STAFF RECOMMENDATION
1500 Dallas Avenue
January 15, 2020

Application: New Construction—Addition
District: Belmont-Hillsboro Neighborhood Conservation Zoning Overlay
Council District: 18
Map and Parcel Number: 11801005500
Applicant: Hunter Conley, Architect
Project Lead: Sean Alexander, sean.alexander@nashville.gov

<p>Description of Project: The applicant proposes to enlarge an historic house with a rear addition that will be wider.</p> <p>Recommendation Summary: Staff recommends approval of the proposed addition with the following conditions:</p> <ol style="list-style-type: none">1. Staff shall approve the roof color and window and door selections; and2. The HVAC units shall be behind the midpoint of the primary building or on the rear. <p>With these conditions, staff finds that the addition meets Section II.B of the <i>Belmont-Hillsboro Neighborhood Conservation Zoning Overlay: Handbook and Design Guidelines</i>.</p>	<p>Attachments</p> <ul style="list-style-type: none">A: PhotographsB: Site PlanC: FloorplansD: Elevations
--	---

Site Layout Plan

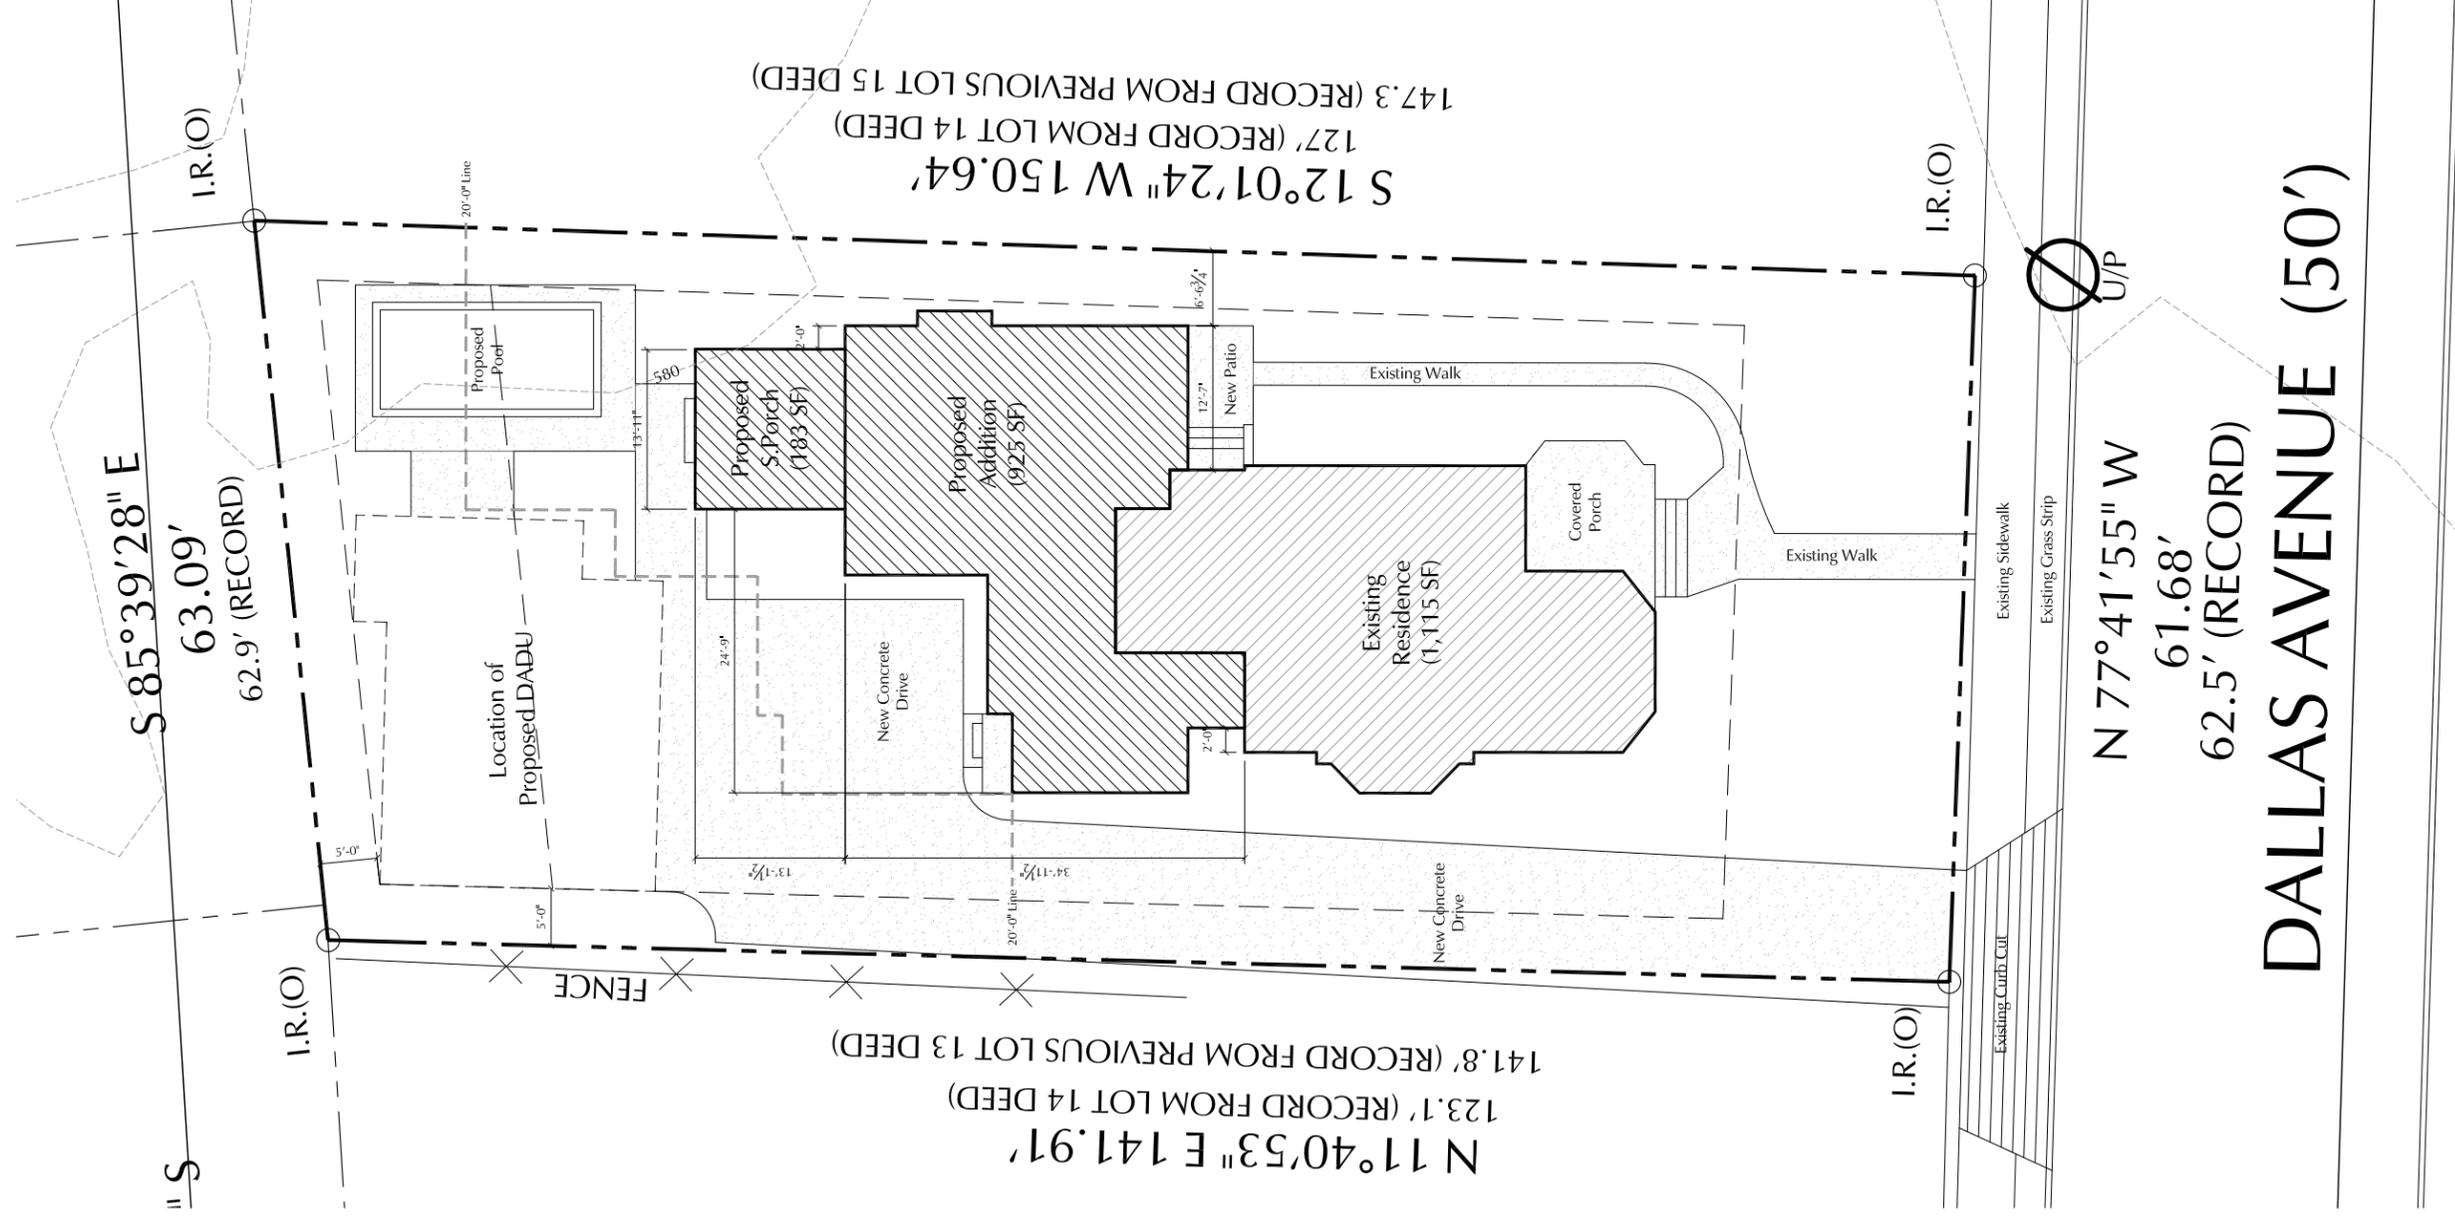
Appurtenances & Utilities: The proposal includes a concrete driveway on the left side of the building and a new and parking areas at the rear, reusing an existing curb-cut. Staff

finds this location to be appropriate. The exterior component of the HVAC unit is currently on the left side of the historic house and is not indicated to be relocated.

Staff recommends that if the HVAC units are relocated, that they be behind the midpoint of the building in order to meet Section II.B.1.h of the design guidelines.

Outbuilding: The outline of a DADU is shown on the site plan near the rear of the lot, but elevations for the outbuilding have not been submitted at this time.

1. Staff shall approve the roof color and window and door selections; and
2. The HVAC units shall be behind the midpoint of the primary building or on the rear.

Elevations

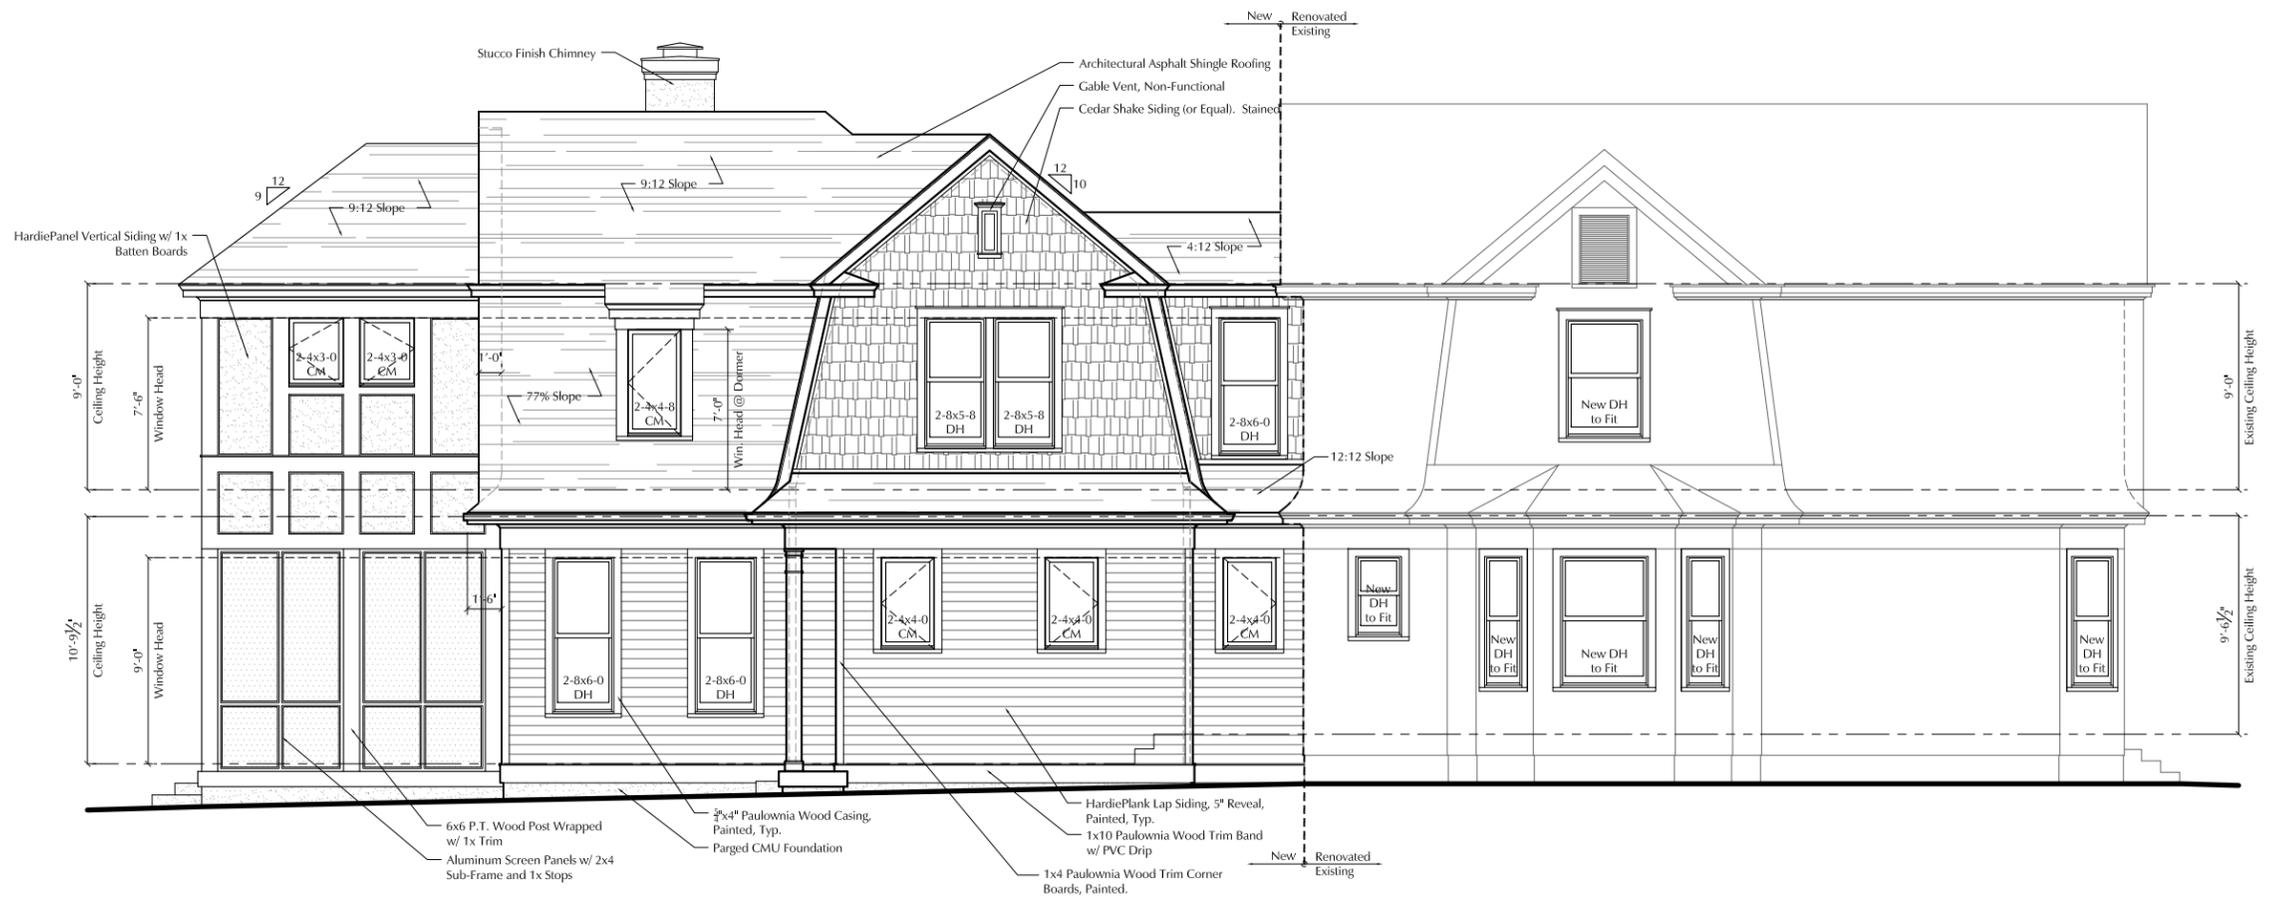
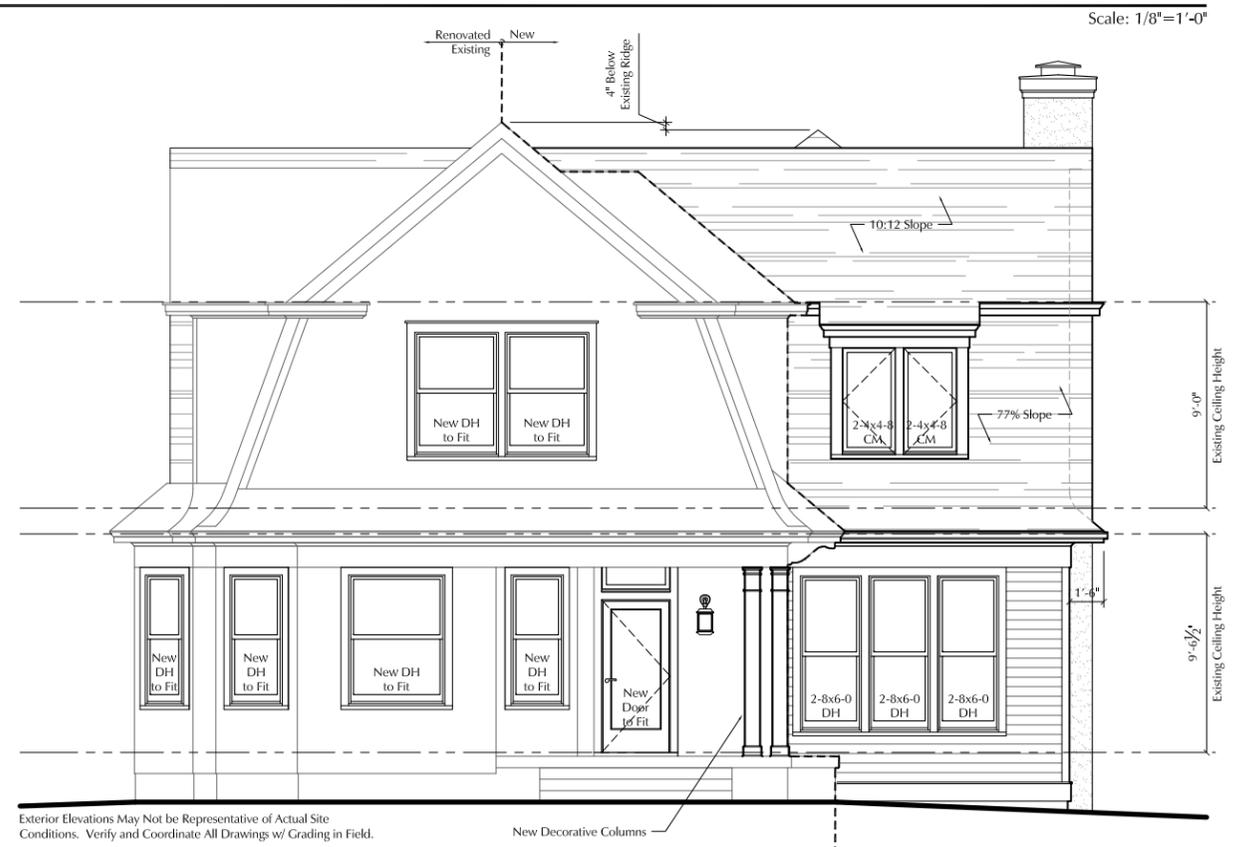
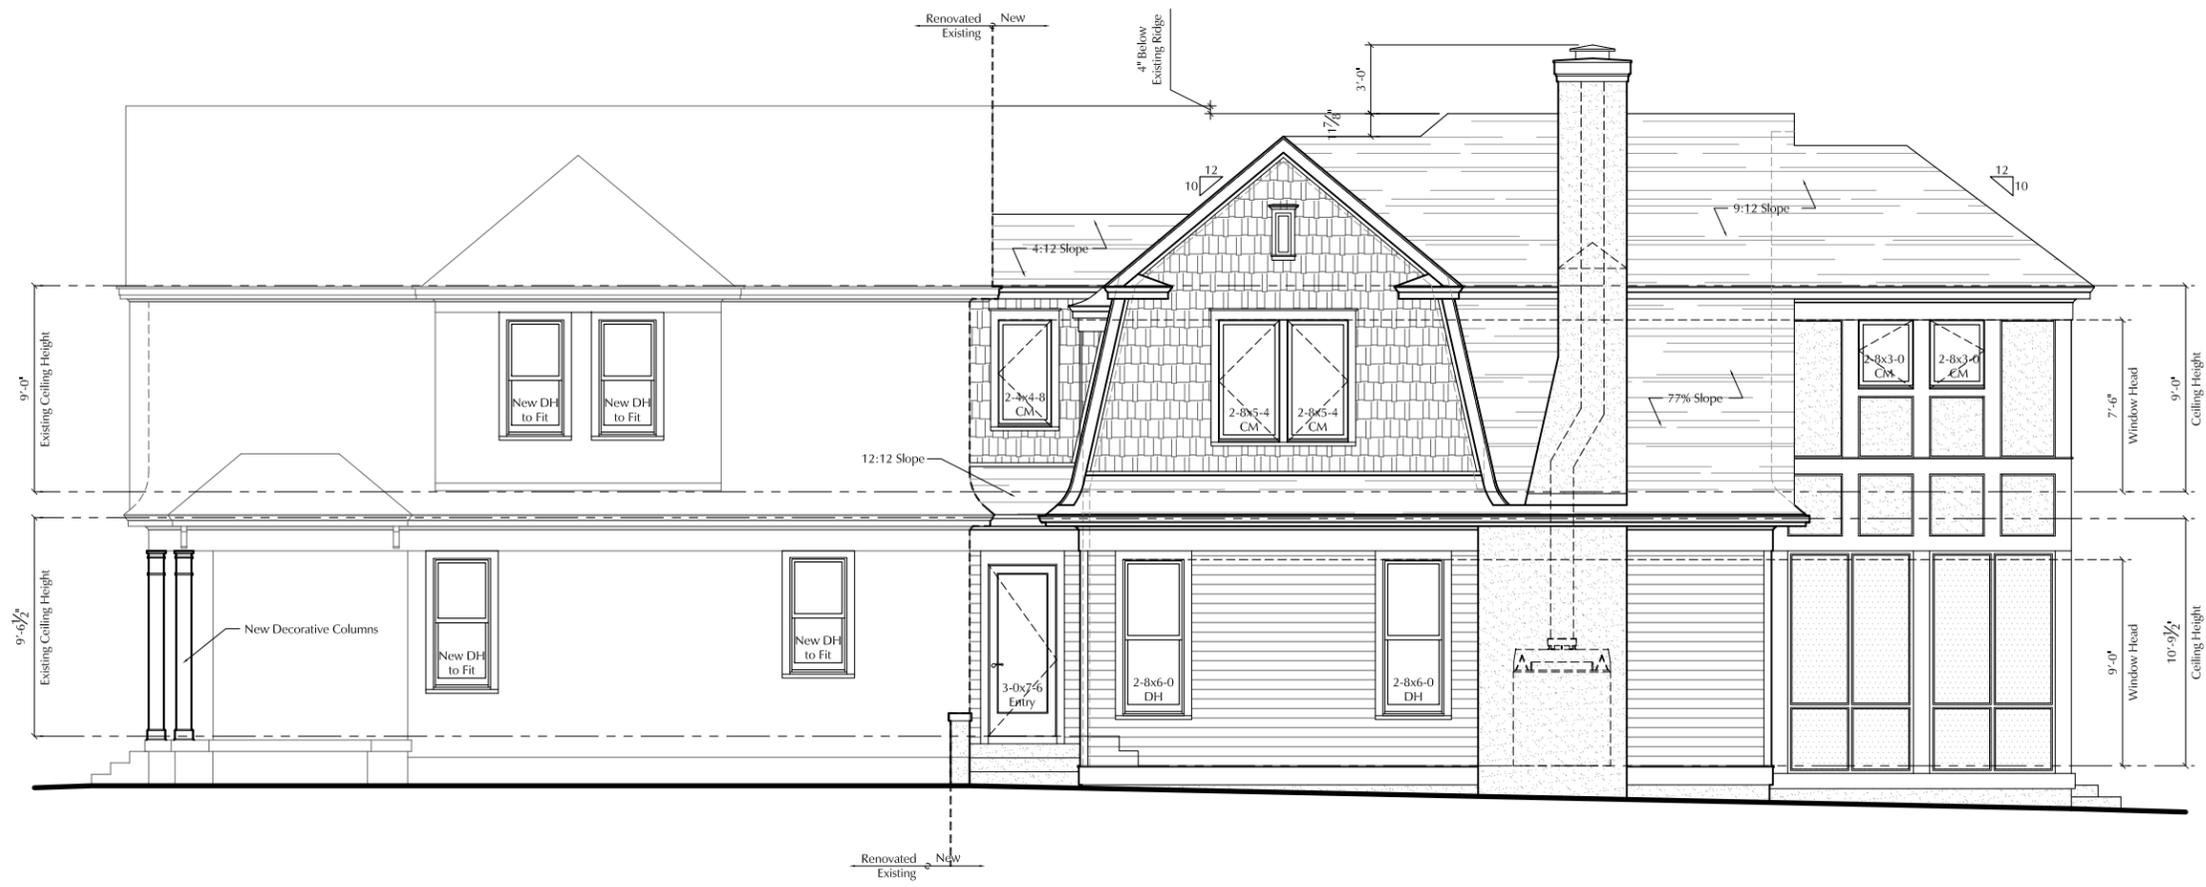
Height & Scale: After attaching to the existing house with a shorter and narrower hyphen, the addition will widen and increase in height. The eaves of the addition will match the eave height of the historic house and the roof ridge, at its peak, be six inches (6") shorter than that of the historic house. Where the addition widens, on the left side it will align with the outside wall of a projecting bay and on the right side it will extend out twelve feet (12') wider than the side of the historic house.

It is generally not appropriate for additions to be wider than an historic house. However, the house at 1500 Dallas Avenue is narrower than other houses on the block by as much as fifteen feet (15'). For this reason, and because the addition is shorter than the historic house, staff finds that the wider addition will be appropriate.

Roof form: The roof of the addition will consist of intersecting gambrel forms. This matches the form of the existing roof, and the 4/12 pitch on the upper slopes and 10/12 pitch on the lower slopes also match the existing roof pitches.

Proportion and Rhythm of Openings: There will be no large expanses of wall on the addition without a window or door opening. The majority of windows on the addition will all be at least twice as tall as they are wide, as is typical of the proportions of windows on the historic house. The first story of the addition will contain three shorter casement windows on the left side. These windows will be similar in proportion to an existing window on the left side of the house and will not be greatly visible because of their location toward the rear.

Staff finds that the height and scale of the proposed addition meets sections II.B.1.a and II.B.1.b of the design guidelines.

Staff finds that the roof forms of the addition are compatible with the historic house and meet section II.B.1.e of the design guidelines.

Staff finds the project's proportion and rhythm of openings to meet Section II.B.1.g of the design guidelines.

Drawings:
Demolition Plans

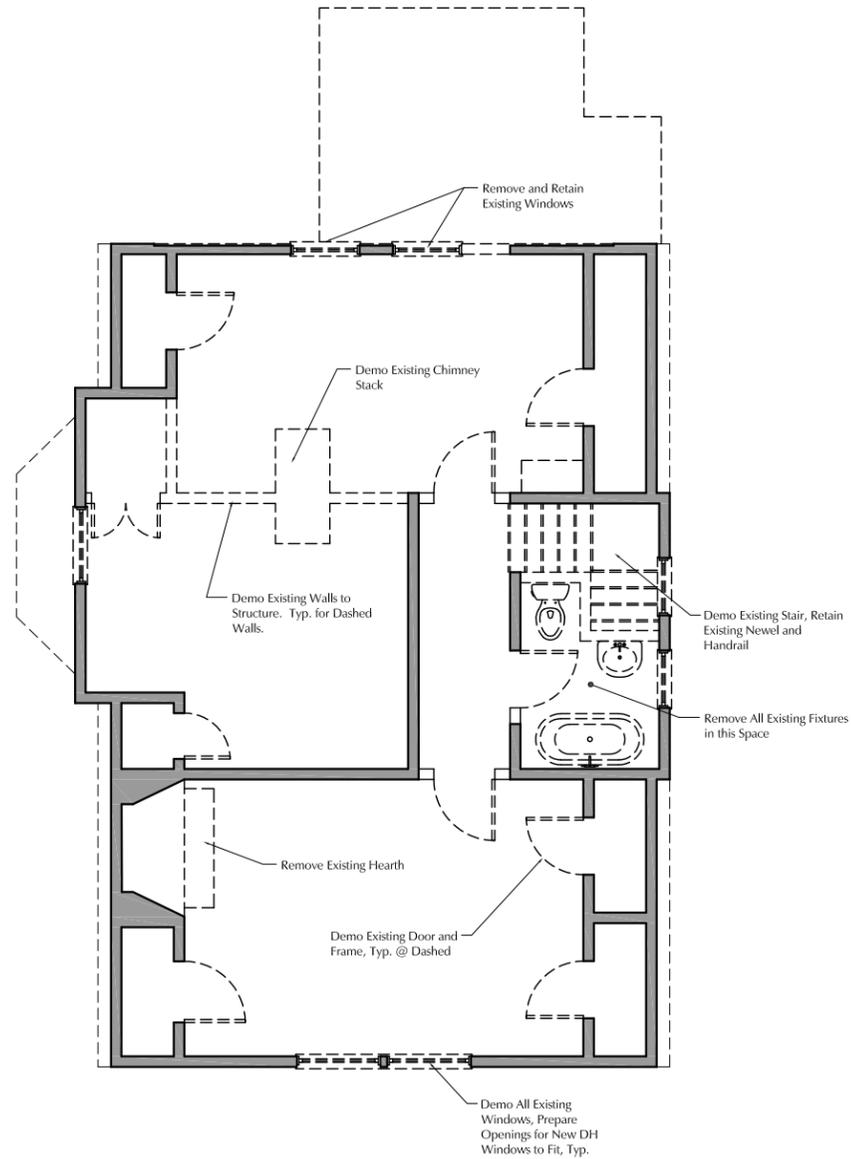
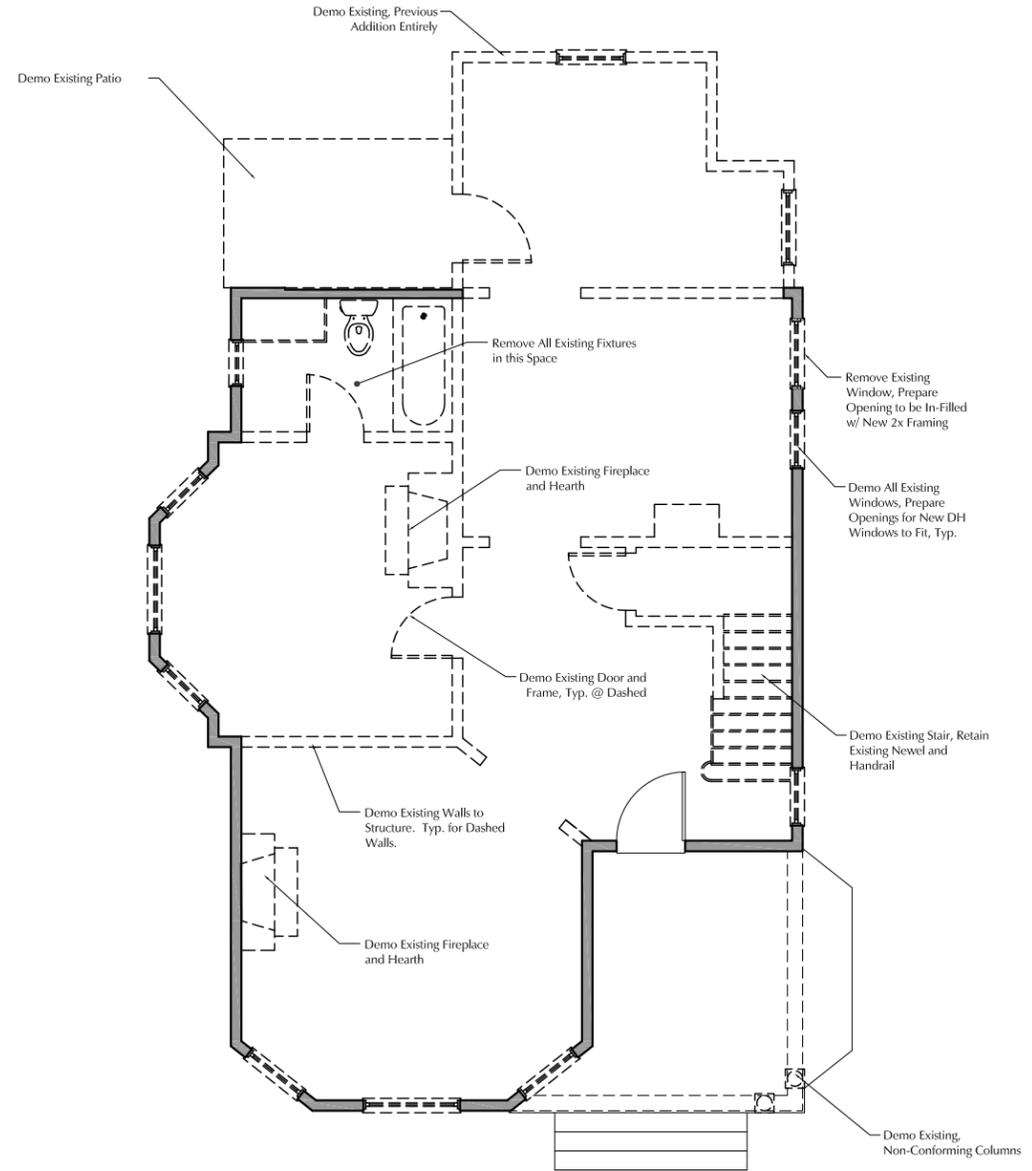
Demolition: The project involves demolishing a portion of the existing rear wall of the house as well as a small previous rear addition to accommodate the new addition. The portions affected are not visible from the street and are not character defining features.

Staff finds that the partial demolition at the rear meets Section V.B.2 of the design guidelines for appropriate demolition.
